# IEEFA Technical Comments on the Orlando Utilities Commission's Draft 2020 Electric Integrated Resource Plan Report

The Orlando Utilities Commission (OUC) has released a draft Electric Integrated Resource Plan (EIRP) to develop a pathway for transitioning to a more sustainable energy future. OUC is to be commended for preparing this draft EIRP, but it has set an unjustifiably short period for its customers to review that draft. Moreover, OUC so far has been unwilling to require its consultant, Siemens PTI, to provide the workpapers and data underlying the analyses in the EIRP. Thus, it is simply impossible to provide complete comments at this time. Moreover, it appears OUC is committed to maintaining its dependence on fossil fuels, a strategy that will make it difficult to achieve the needed transition to no-carbon fuels.

**Figure 1: The Decline in OUC Annual CO<sub>2</sub> Emissions From 2005 Base Year To the Years 2017-2019<sup>3</sup>**

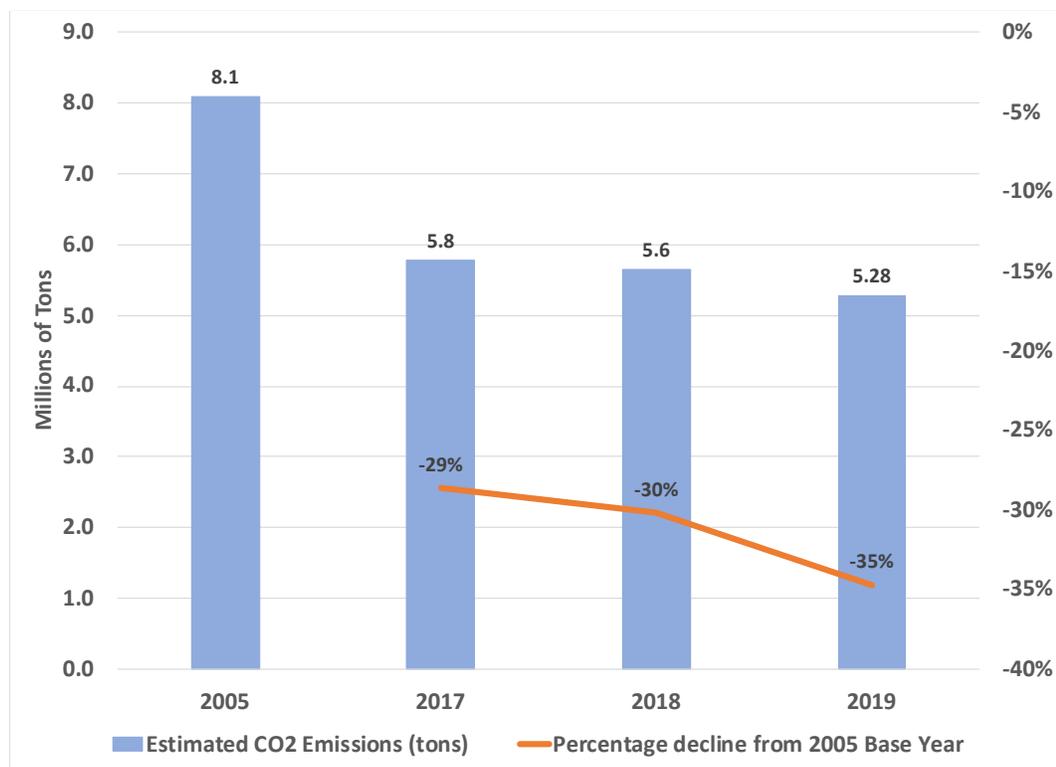
Second, OUC's proposed CO<sub>2</sub> reduction goals are based on percentage declines from a 2005 base year that unfortunately is the standard for the industry. As shown in Figure 1 below, OUC's CO<sub>2</sub> emissions declined by about 36% between 2005 and 2019. Therefore, OUC would need to reduce its CO<sub>2</sub> by only another 14 to 15% from 2019 to 2030 to achieve its 2030 interim goal, and by another 39% to achieve its 2040 interim goal—not exactly an aggressive goal.
